ADDENDUM NO. 4

RFQ CCC-056

**New Student Services Building
Compton Community College District**

tBP Project. No. 20987.00

drawing no.:
A4-1
 drawing of

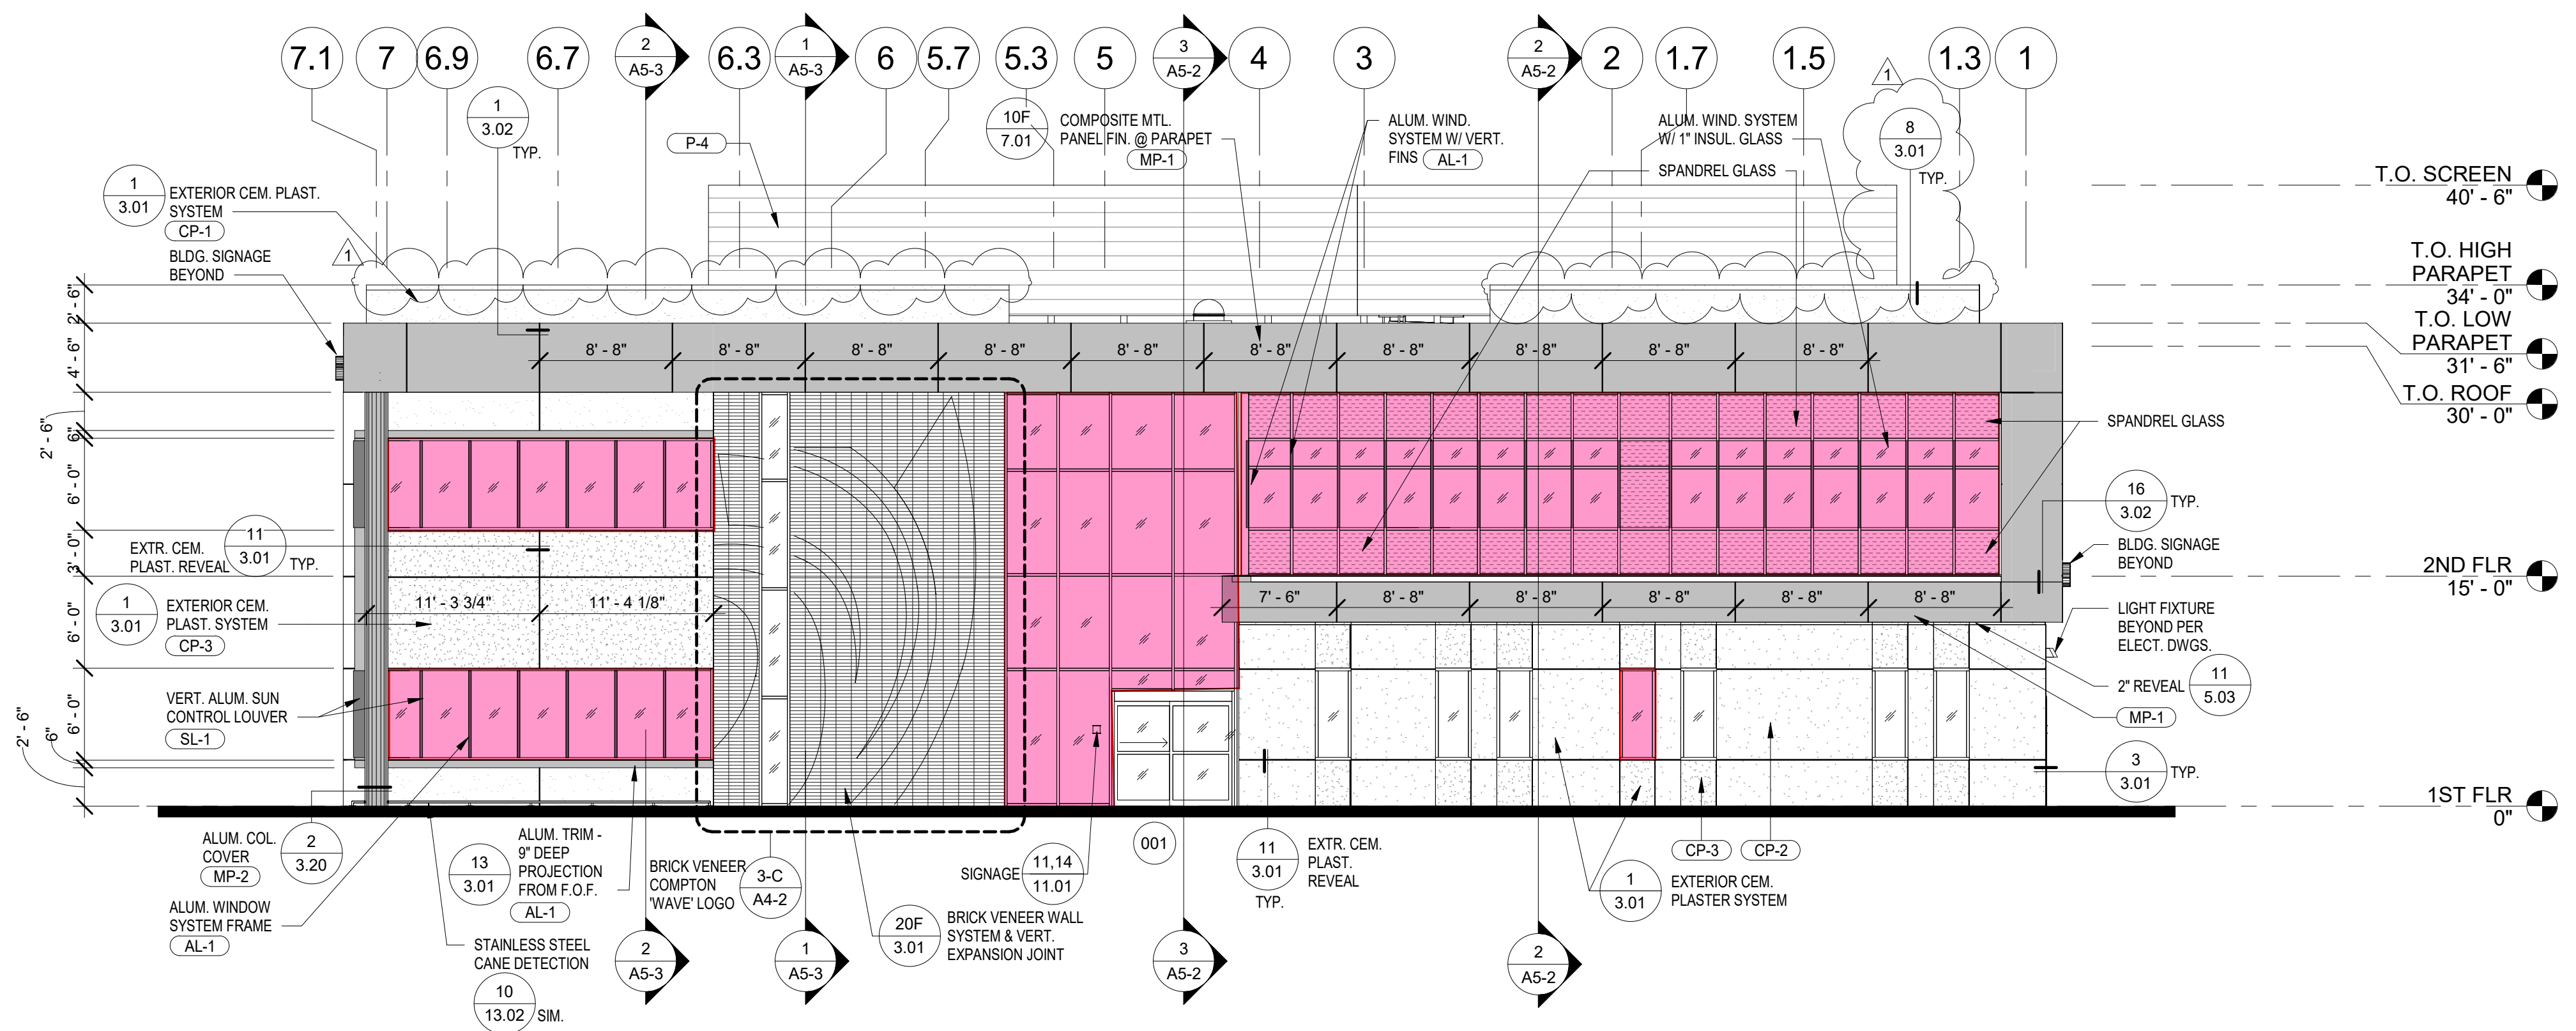
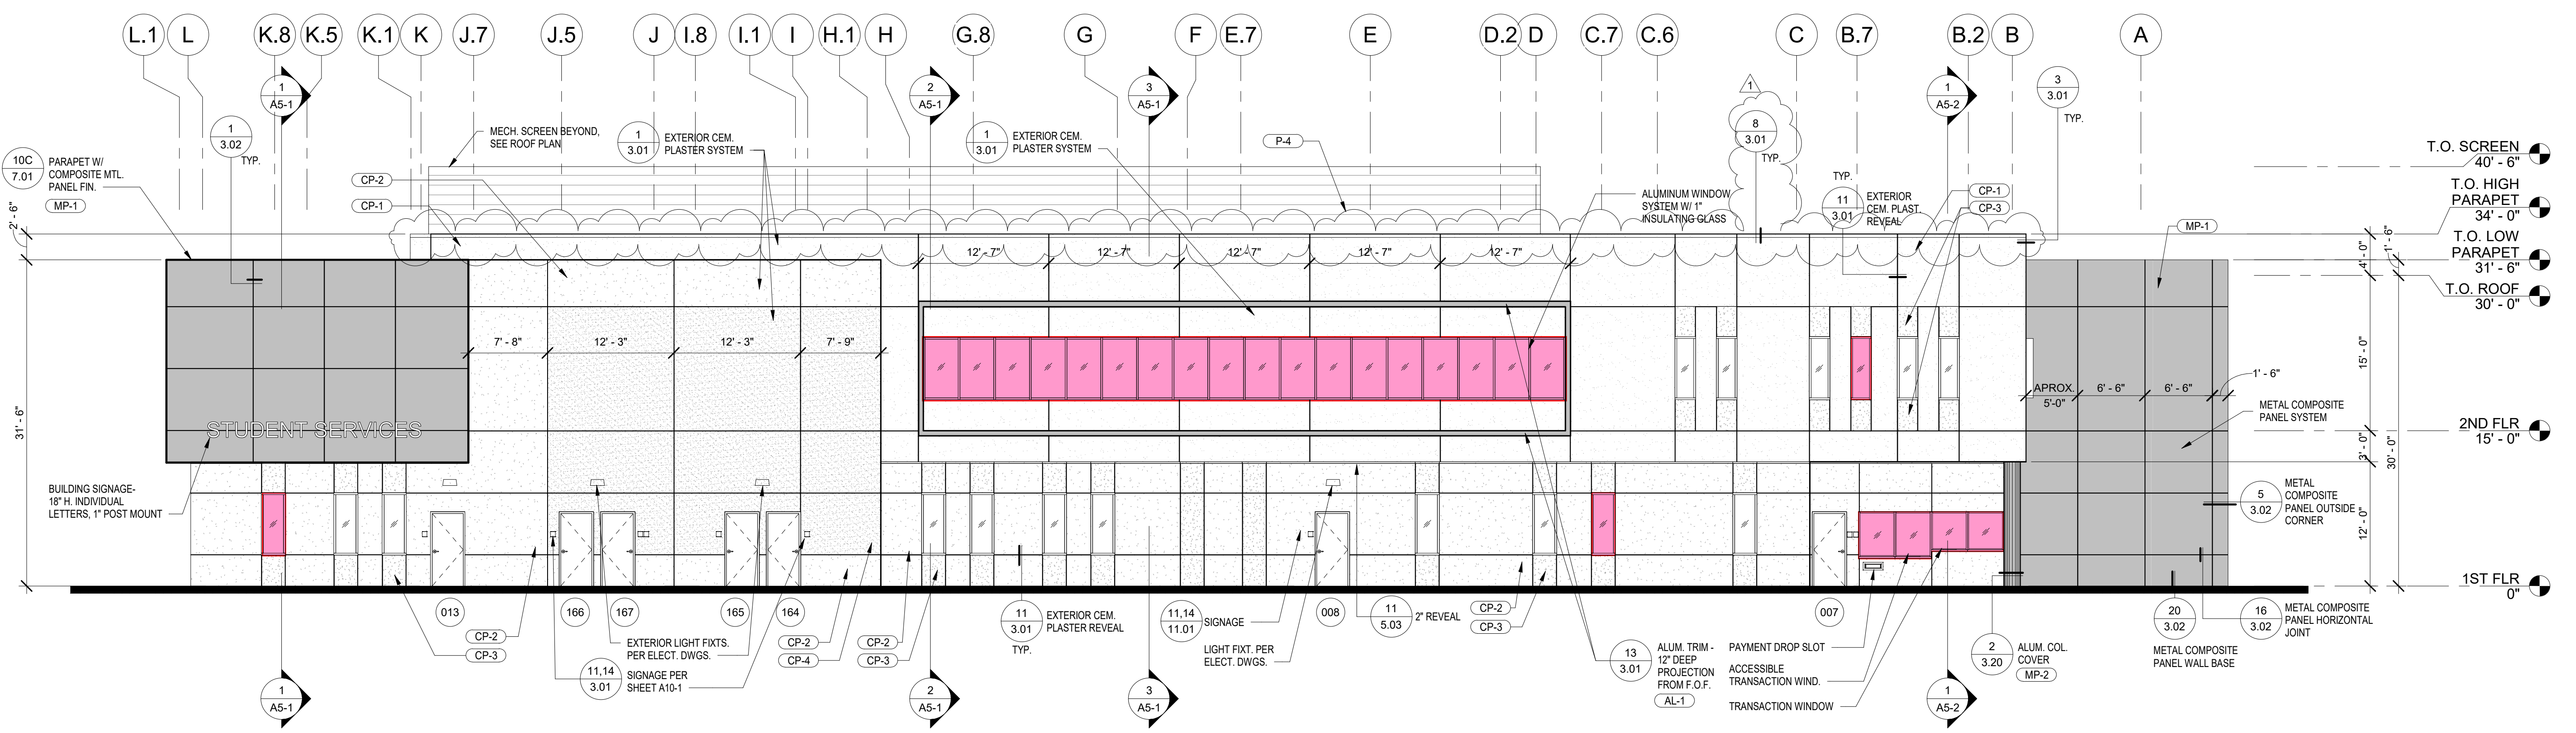
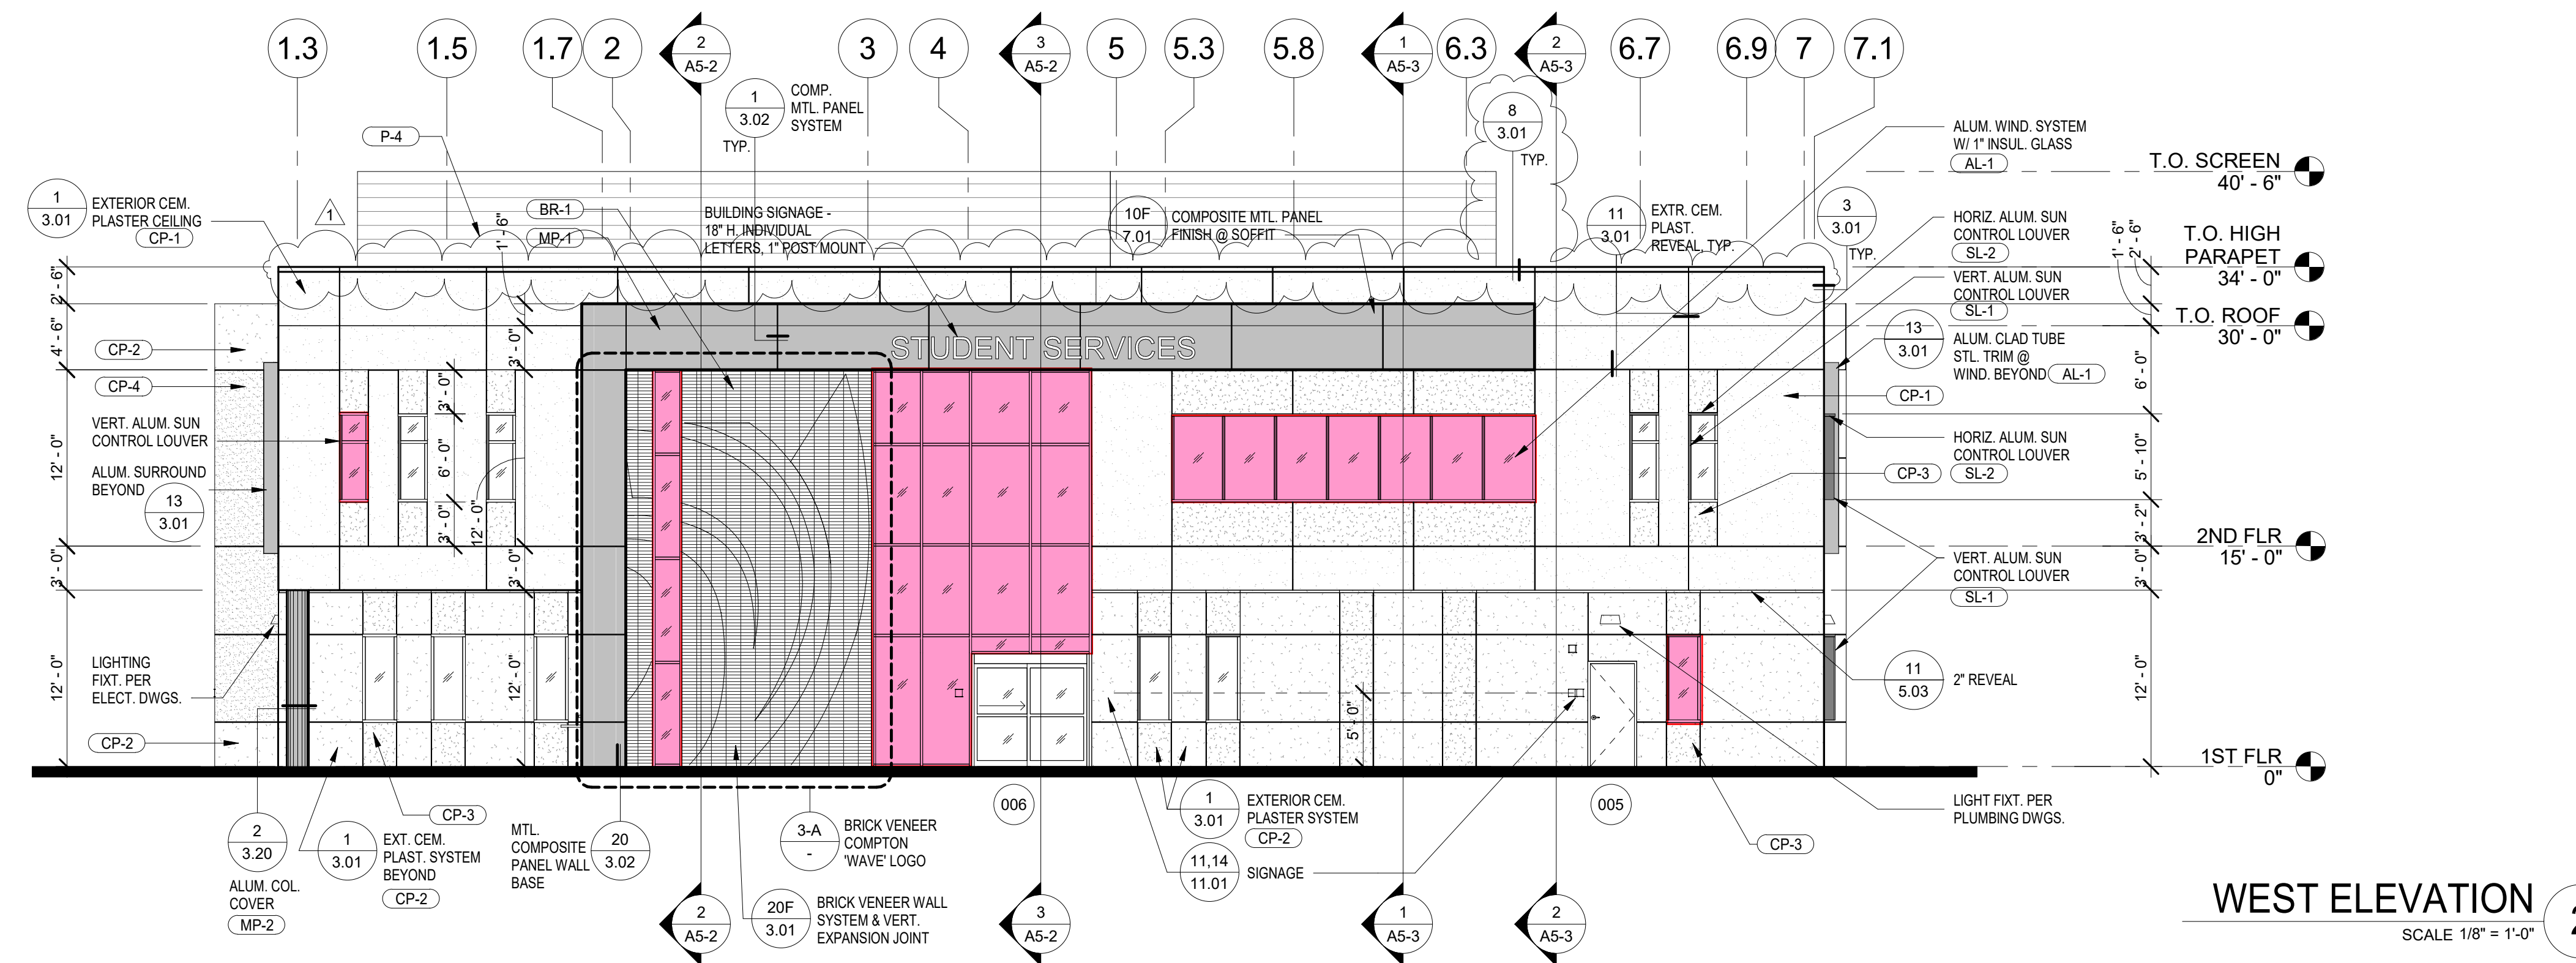
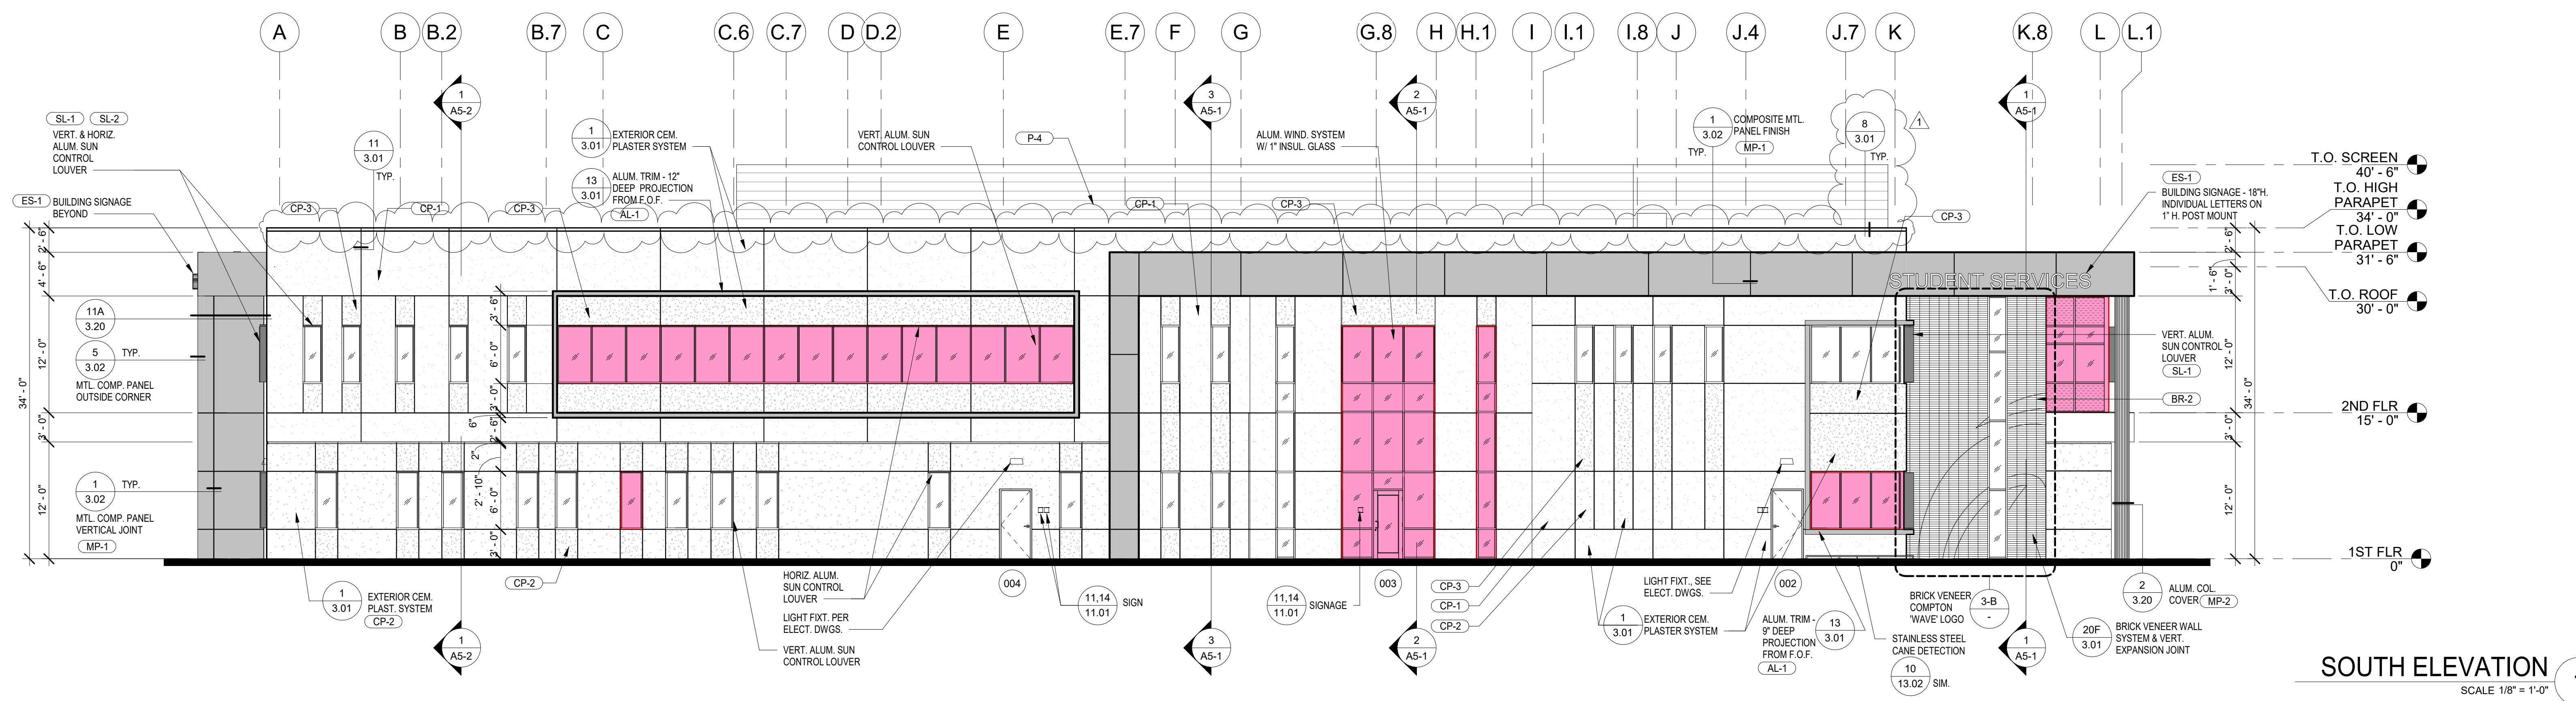
22	Per spec section 08 44 13 - 3.04.C.1 - Please provided locations of designated area to be tested (none shown on the drawings).	Spec Section 08 44 13 - 3.04.C.1	Please see exterior elevation sheets A4.1 and A4.2 attached to this Addendum #4. The highlighted windows are to be tested.
23	Per spec section 08 44 13 - 3.04.C.3 - Please clarify if this is for the testing of all storefront and glazing on the project	Spec Section 08 44 13 - 3.04.C.3	3.This test applies to all glazed aluminum curtain wall systems. Refer to section 08 43 13 Part 3.04 for water testing of Aluminum framed storefronts.
24	Is there a construction schedule you can provide for this project?		Reference Specification Section 01 43 80 provided in the "RFQ CCC-056 Student Services Contract Documents" posted on the District's bid website.
25	Sheet 114/A9-1 is showing projection screens and flat panel displays with a note of "FFE by District." Can you clarify what FFE means and that the district will be providing these? If the district is providing these screens & displays will the AV contractor be responsible for installing?	Sheet 114/A9-1	The FF&E on this project will be provided and installed by District Vendors. The contractor is not responsible to install the items, just provide the infrastructure and in some cases final connections to the FF&E items such as electrical connections to furniture.
